UNITED STATES PATENT AND TRADEMARK OFFICE

Office Action Summary	Application No. 10/598,292	Applicant(s) FRANCK ET AL.	
	Examiner RYAN A. VARNUM	Art Unit 3751

DETAILED ACTION

Annotated Fig. 7

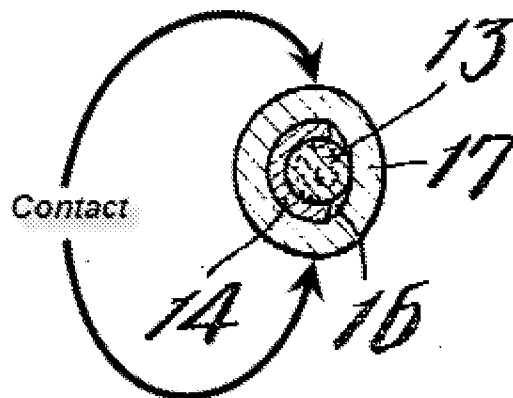
7. In re Claims 12, 13 and 17, Minagawa further discloses said brake 17 (Fig. 6), considered perpendicularly to the axis X (as depicted in Fig. 7), includes an elongate shape (See Fig. 7), wherein regions of said endpiece-lead brake friction being formed at each end of the elongate shape ("contact"; See Annotated Fig. 7 below; it being understood that endpiece 4 being circular will contact both of these points); said lead brake includes an annular shape (See Fig. 7); and said lead brake includes a torus-shape before being fitted on said lead guide (See Fig. 7).

11. In re Claim 16, Minagawa discloses two diametrically opposed regions of endpiece-lead brake friction ("contact"; See Annotated Fig. 7 above; said "contact" points being locations wherein brake 17 contacts endpiece 4, such contact resulting in a friction force); and a region of lead-lead brake friction (See Fig. 7; friction occurring between the two members where brake 17 contacts lead 13), the regions of endpiece-

lead brake friction being angularly shifted about 90 degrees relative to the region of lead-lead brake friction (it being understood that, where the contact and thus friction forces between brake 17 and endpiece 4 occur over a circular region, there will necessarily be regions of endpiece-lead brake friction which are angularly shifted about 90 degrees relative to the region of lead-lead brake friction).
